# UNITED STATES PATENT AND TRADEMARK OFFICE

10/723,936

Declan Somerville

<b>Office Action Summary</b>	<b>Application No.</b> 10/723,936	<b>Applicant(s)</b> SOMERVILLE, DECLAN	
	<b>Examiner</b> Paul Devoti	<b>Art Unit</b> 3637

Bukky (US Patent Number 6823814) Figure 1

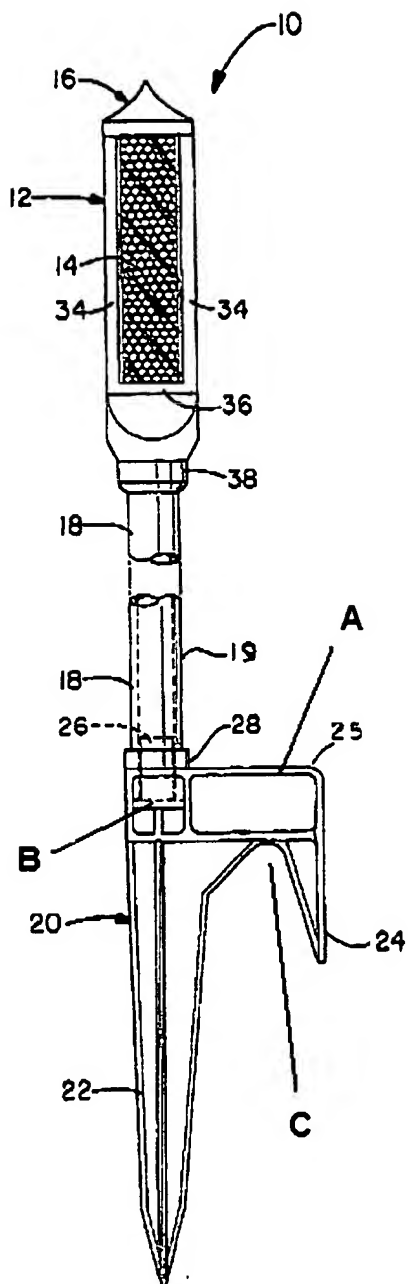
8. Claims 1, 2, 5, and 13 are rejected under 35 U.S.C. 102(b) as being anticipated by Bukky (US Patent Number 6823814). Bukky discloses a stake support with a lowermost portion (24) and an offset portion (25) connecting the lowermost portion to an uppermost portion (18) that is axially offset from the lowermost portion (24).

Additionally, an open platform directly above the lowermost portion (24) is disclosed by offset portion (25) that inherently serves as a hammer point when driving the lowermost portion into the ground. Regarding claim 2, Bukky discloses that the lowermost portion (24) is, in use, located below the ground surface, and the uppermost portion (18) is located above the ground surface. Regarding claim 5, the offset portion (25) extends at a right angle to the lowermost portion and includes parallel upper (A) and lower (B) frame members. Regarding claim 13, Bukky discloses a removal wedge consisting of an asymmetric notch (C) cut downwardly from the offset portion (25).

Blankemeyer et al. (US Patent Number 3732878) Figure 2

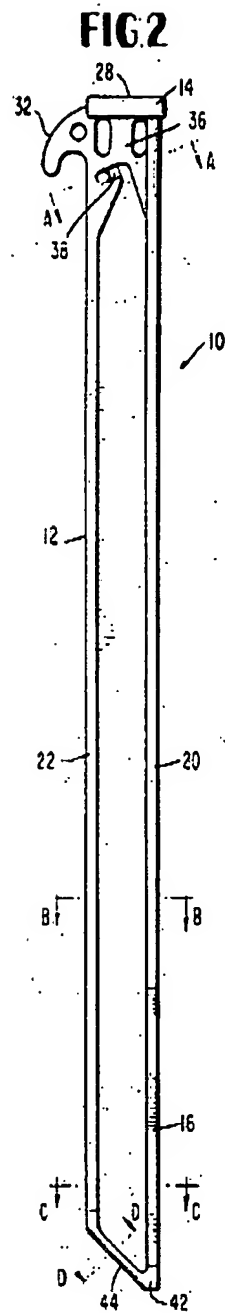
10. Claim 3 is rejected under 35 U.S.C. 103(a) as being unpatentable over Bukky in view of Blankemeyer et al. (US Patent Number 3732878). Bukky discloses everything previously mentioned, but does not teach an I-shaped member where a first side element extends further and is longer than a second side element, and the lower end of the lowermost portion forms a point. Blankemeyer et al., however, teaches an I-shaped member (12) where a first side element (20) extends further and is longer than a second side element (22) and forms a point (42). Therefore it would have been obvious to one having ordinary skill in the art at the time of invention to modify Bukky's stake device to include a lowermost portion with an I-shaped member, as taught by Blankemeyer to easily and securely drive the lowermost portion into the ground.

Jewett et al. (US Patent Number 6237289) Figure 8

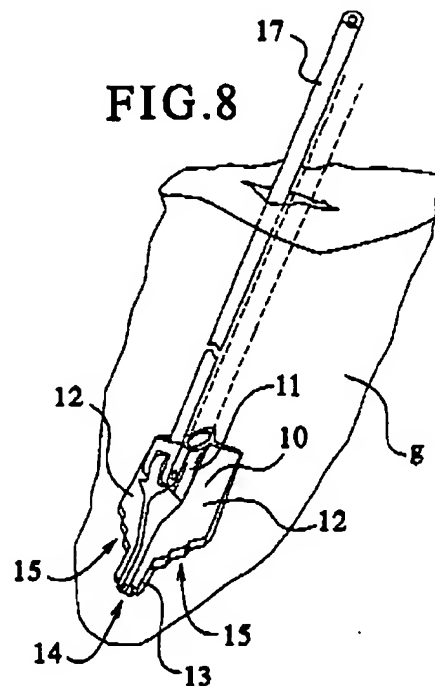
11. Claim 4 is rejected under 35 U.S.C. 103(a) as being unpatentable over Bukky in view of Blankemeyer as applied to claim 3 above, and further in view of Jewett et al. (US Patent Number 6237289). Bukky in view of Blankemeyer discloses everything previously mentioned, including a bottom edge extending slopingly between the first (20) and second side elements (22), but does not teach that the bottom edge includes an indented shoulder portion. Jewett et al., however, teaches a stake device having an indented shoulder portion (15) on the bottom edge. Therefore it would have been obvious to one having ordinary skill in the art at the time of invention to further modify Bukky's garden stake support, already modified by Blankemeyer, to include an indented shoulder portion on the bottom edge of the lowermost portion as taught by Jewett et al. to further facilitate penetration of the lowermost portion into the ground.

Kleinhesselink (US Patent Number 1555322) Figure 2

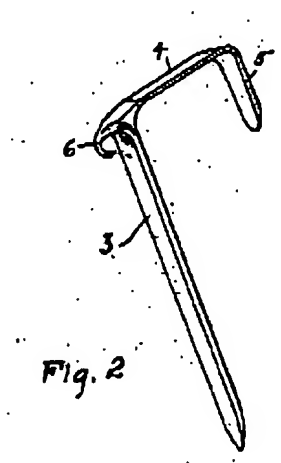
12. Claim 6 is rejected under 35 U.S.C 103(a) as being unpatentable over Bukky in view of Kleinhesselink (US Patent Number 1555322). Bukky discloses everything previously mentioned, but does not teach a curled tongue extension on the outer side of the lower frame member. Kleinhesselink, however, teaches a hook (6) on the outer side of the frame member (4) of a stake. Therefore, it would have been obvious to one having ordinary skill in the art at the time of invention to modify Bukky's stake support to include a curled tongue extension on the outer side of the frame member, as taught by Kleinhesselink to engage and hold an element such as a rope or pipe.

13. Claim 7 is rejected under 35 U.S.C 103(a) as being unpatentable over Bukky in view of Kleinhesselink. The upper (A) and lower (B) parallel frame members of the offset portion (25) are capable of providing space for a branch pipe member to extend from a supply pipe towards the uppermost portion.

Despino (US D445054) Figure 6

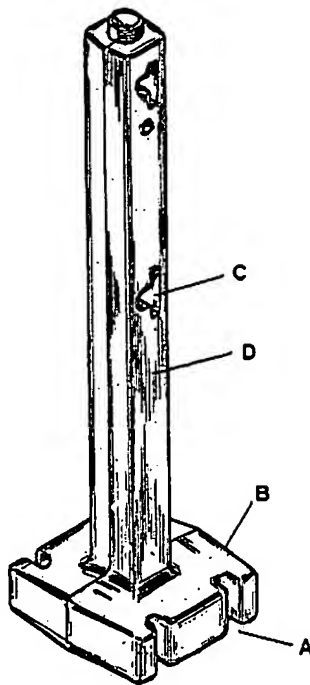
15. Claim 10 is rejected under 35 U.S.C. 103(a) as being unpatentable over Bukky in view of Fitzsimmons as applied to claim 8 above, and further in view of Despino (US D445054). Bukky discloses everything mentioned, but does not teach a notch cut into the first ledge and collar on opposing sides of the base member where the notches are axially aligned on either side of the stake base member. Despino, however, teaches a structure with notches (A) on the base member (B) and notches (C) on the upper

member (D), which are axially aligned on either side of the base member (B).

Therefore, it would have been obvious to one having ordinary skill in the art at the time of invention to modify Bukky's stake, already modified by Fitzsimmons, to include notches on the base member and collar on the upper member, as taught by Despino, to securely attach and hold a member such as a pipe.

Ferreira (US Patent Number 304683) Figures 5, 5a, and 8

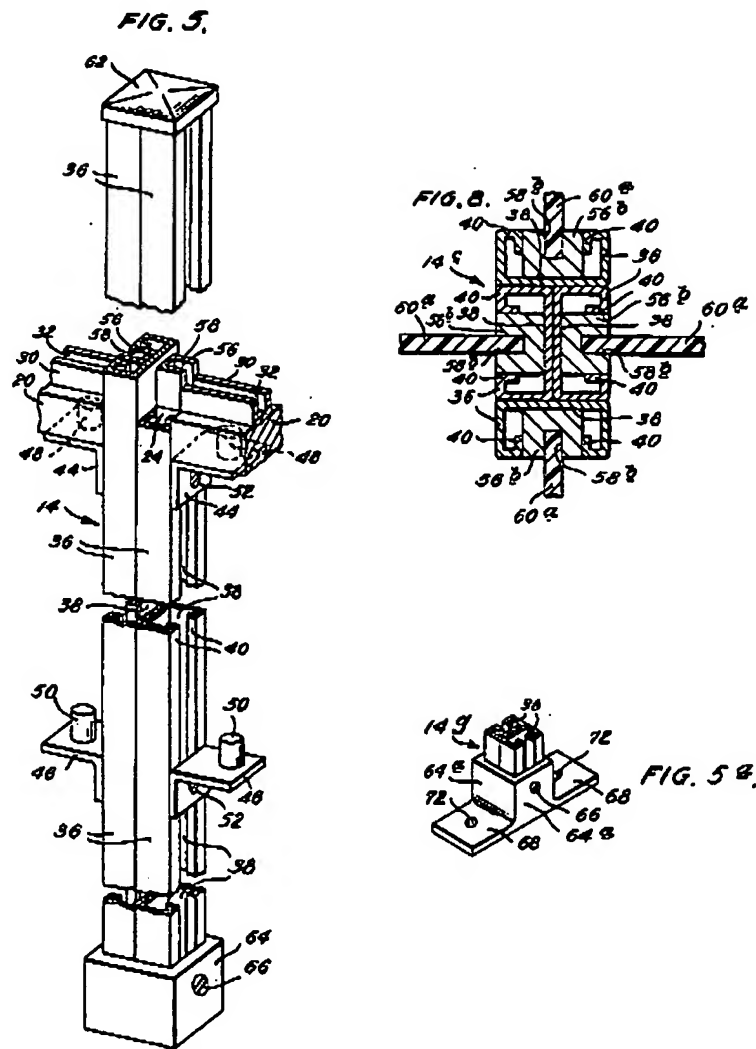
16. Claims 11 and 12 are rejected under 35 U.S.C. 103(a) as being unpatentable over Bukky in view of Fitzsimmons and Despino as applied to claim 10 above, and further in view of Ferreira (US Patent Number 3304683). Bukky in view of Fitzsimmons and Despino discloses everything previously mentioned, but does not teach an

interlocking section with an extrusion that in cross section takes the form of a back-to-back C-shaped element and that the interlocking section is formed of two interlocked back to back C-shaped elements forming a stable structure, where the second back to back C-shaped element is partially located within one back to back C-shaped element and is received in slots in the upper edge of the base member. Ferreira, however, discloses an interlocking upright section (36) in a base section (64), where the cross section of the interlocking section (36) takes the form of a back-to-back C-shaped element. Ferreira also teaches an interlocking section (36) formed of two interlocked back to back C-shaped elements, where the second back to back C-shaped element is located within one back to back C-shaped element (Figure 8) and is received in slots in the upper edge of the base section (64). Therefore, it would have been obvious to one having ordinary skill in the art at the time of invention to modify Bukky's stake, already modified by Fitzsimmons and Despino, to include an interlocking section with an extrusion that in cross section takes the form of a back-to-back C-shaped element and also an interlocking section (36) formed of two interlocked back to back C-shaped elements, where the second back to back C-shaped element is located within one back to back C-shaped element and is received in slots in the upper edge of the base section (64), as taught by Ferreira to provide a strong, secure, and easily manufactured interlocking section.
